PCN #: 2477 **REV 3 – FINAL UPDATE**

PCN Title: Additional Wafer Source (GFAB), Additional Assembly/Test (A/T) Site (SAT), and Transfer Assembly/Test Site to DIYI

**PRODUCT CHANGE NOTICE****PCN-2477 REV 3 –
FINAL UPDATE**

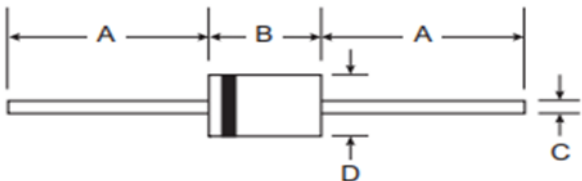
Note: "***" Change package dimension as listed below (DO-41)

Package	From : Current Baseline	Change To : DIYI																																										
DO-41	<table border="1"> <thead> <tr> <th colspan="3">DO-41</th></tr> <tr> <th>Dim</th><th>Min</th><th>Max</th></tr> </thead> <tbody> <tr> <td>A</td><td>25.4</td><td>--</td></tr> <tr> <td>B</td><td>4.1</td><td>5.2</td></tr> <tr> <td>C</td><td>0.71</td><td>0.86</td></tr> <tr> <td>D</td><td>2</td><td>2.7</td></tr> <tr> <td colspan="3">All Dimensions in mm</td></tr> </tbody> </table>	DO-41			Dim	Min	Max	A	25.4	--	B	4.1	5.2	C	0.71	0.86	D	2	2.7	All Dimensions in mm			<table border="1"> <thead> <tr> <th colspan="3">DO-41</th></tr> <tr> <th>Dim</th><th>Min</th><th>Max</th></tr> </thead> <tbody> <tr> <td>A</td><td>25.4</td><td>--</td></tr> <tr> <td>B</td><td>4.1</td><td>5.2</td></tr> <tr> <td>C</td><td>0.6</td><td>0.8</td></tr> <tr> <td>D</td><td>2</td><td>2.7</td></tr> <tr> <td colspan="3">All Dimensions in mm</td></tr> </tbody> </table>	DO-41			Dim	Min	Max	A	25.4	--	B	4.1	5.2	C	0.6	0.8	D	2	2.7	All Dimensions in mm
